Government response to consultations on offshore electricity transmission

Annex 2: Grid Code

15 December 2010

This Annex sets out the changes made by the Secretary of State to the Grid Code following consideration of responses to the changes proposed in the November consultation.

Figure 1

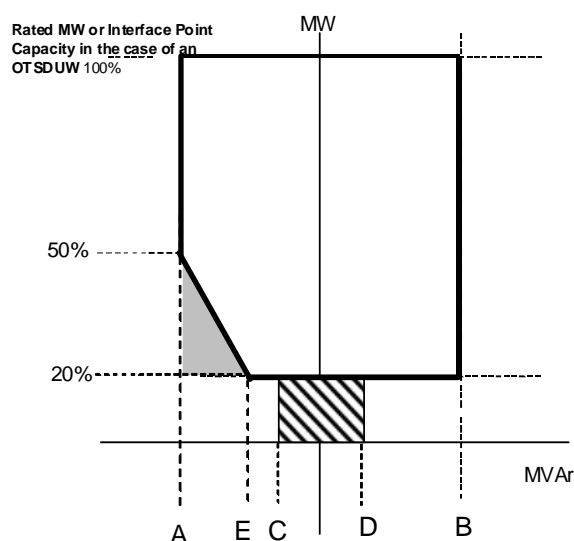
¹ Please note that Figure 1 has an unmarked change in the title of the table.

Figure CC.A.7.2.2b

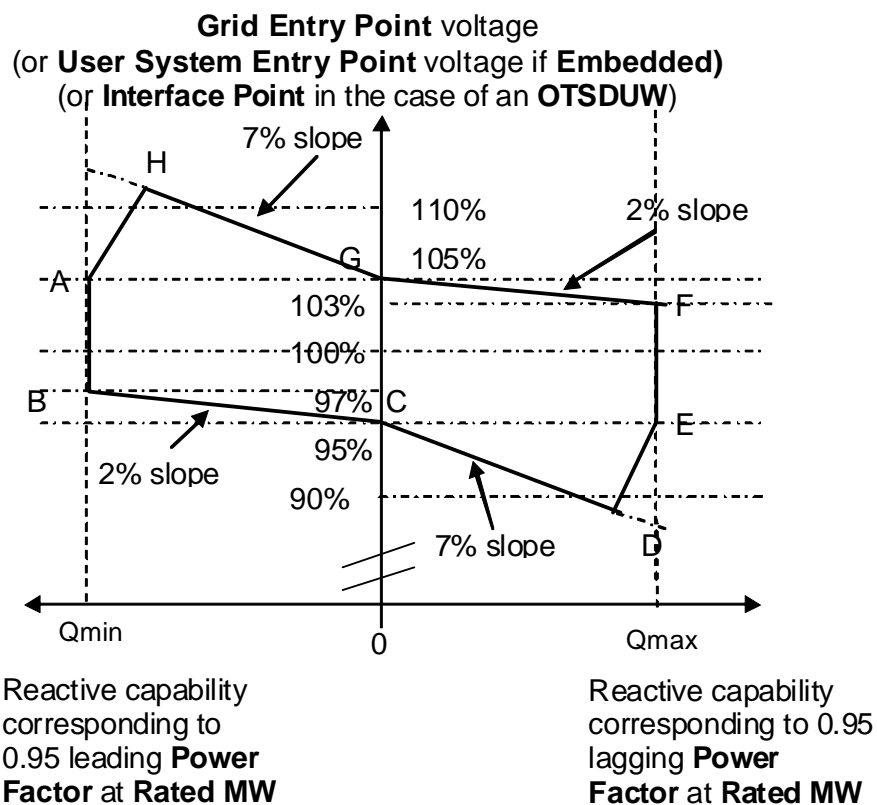
² Please note that Figure A.7.2.2.b has an unmarked change.
